RE: Preliminary Plan # 1-1998107B  
Downtown Silver Spring

SUBJECT: Downtown Silver Spring (Sections B & E)  
Amendments to the Project Plan #9-1998005B  
Site Plan # 8-1999002F and Preliminary Plan #1-1998107B  
Silver Spring Central Business District Sector Plan

SUBJECT: Site Plan Amendment 81999002F  
Preliminary Plan Amendment 11998107B  
Downtown Silver Spring

SUBJECT: Project Plan Review No. 9-1998005B  
Site Plan No. 8-1999002F  
Preliminary Plan No. 1-1998107B  
Downtown Silver Spring, residential phase

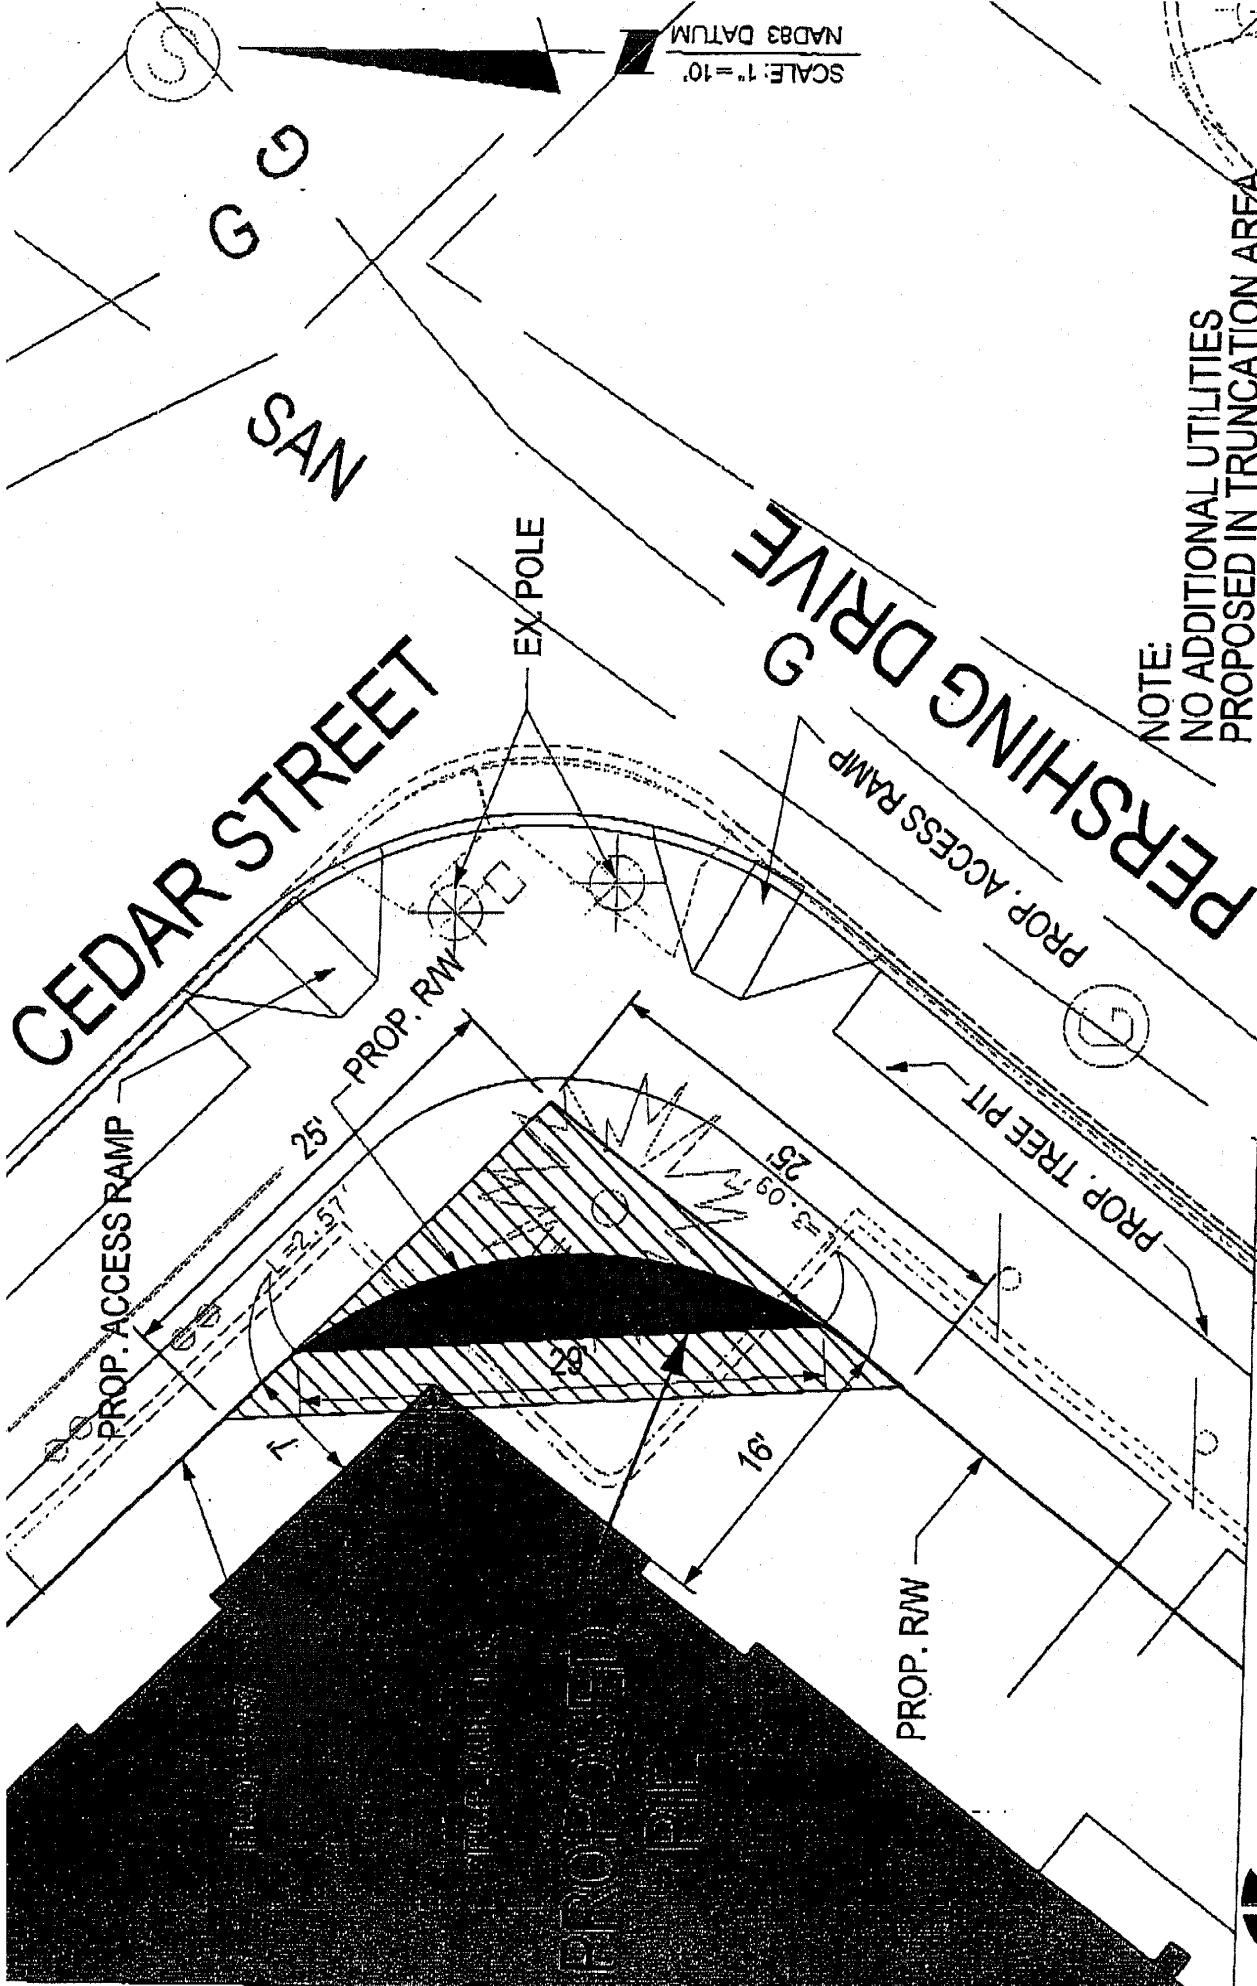
The driveway on Cedar Street will be designed and constructed with physical channelization to prohibit left turns out of the site (all other movements will be allowed).

We remain concerned about ultimate visibility (looking to the left) from the exit on Cedar Street due to the horizontal and vertical geometries of the road, as well as the proposed street tree placement. Street trees will not be permitted closer than thirty (30) feet apart, in accordance with typical streetscaping design. To further address the ultimate sight distances concern, we have agreed to defer approval of the exact tree locations to the permit stage.

\* PROVIDE PHYSICAL CHANNELIZATION  
ON DRIVEWAY TO PROHIBIT LEFT TURN EXITS  
FROM THE SITE (ALL EXITING TRAFFIC MUST  
TURN RIGHT FROM THE SITE) *gull*

# DT Silver Spring Proposed Shared Use Trail Alignment

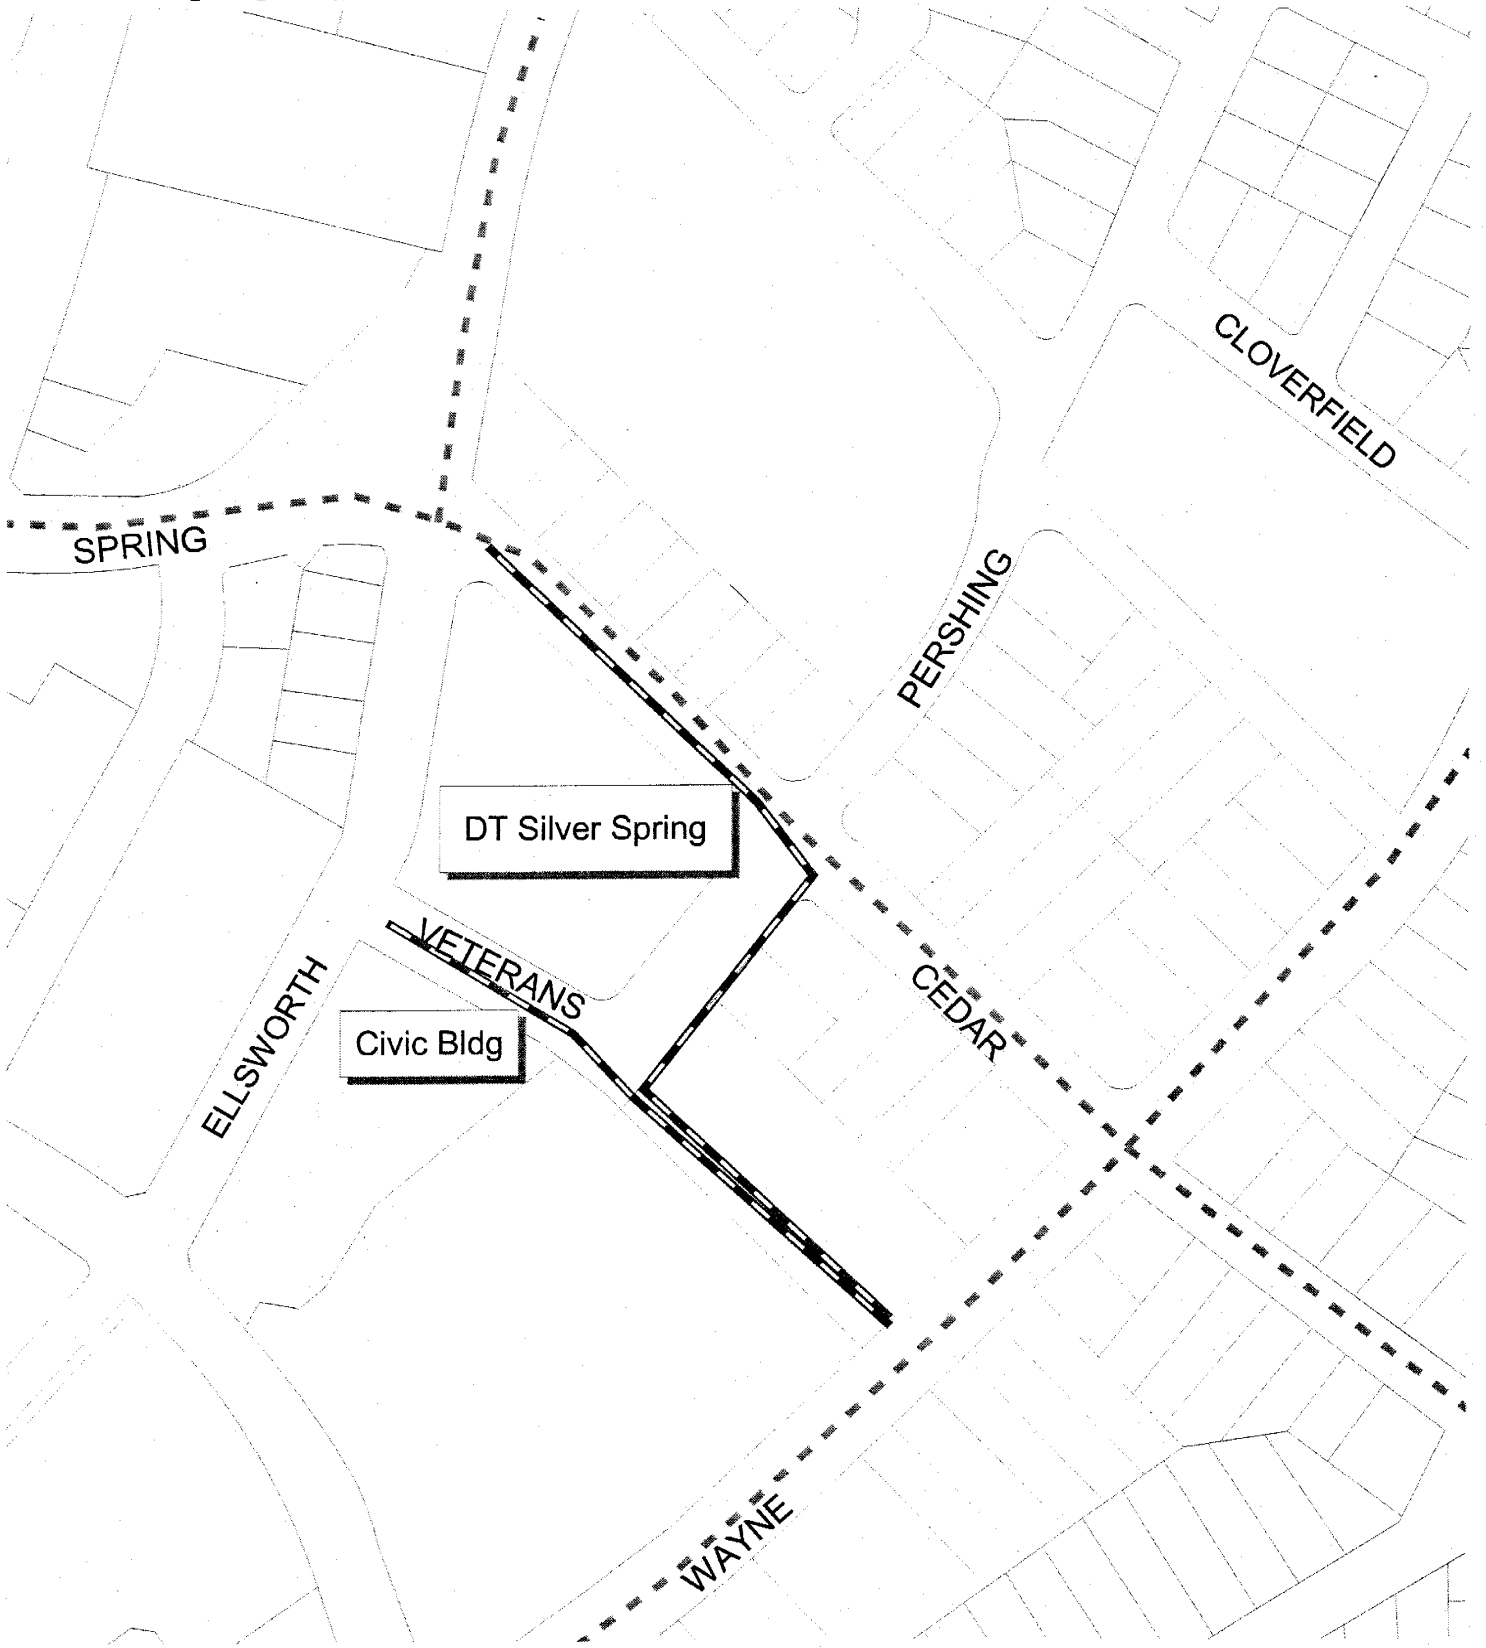
The Silver Spring Central Business District Sector Plan recommends on-road bicycle routes on Cedar Street and the creation of an off-road trail along Pershing Drive and Cedar Street with connection to Ellsworth Drive. Transportation Planning staff recommends an alternate route following the proposed Veterans Place roadway alignment from Pershing Drive to Ellsworth Drive (please see attachment). Staff's recommendation is a more direct route between Wayne Avenue and Ellsworth Drive and would also provide access to the proposed Civic Building. Either alignment meets the intended purpose of providing connection between the Silver Spring Green Trail along Wayne Avenue and Sligo Creek Parkway. Final determination of the need and ultimate alignment of this trail connection is anticipated at a future date.
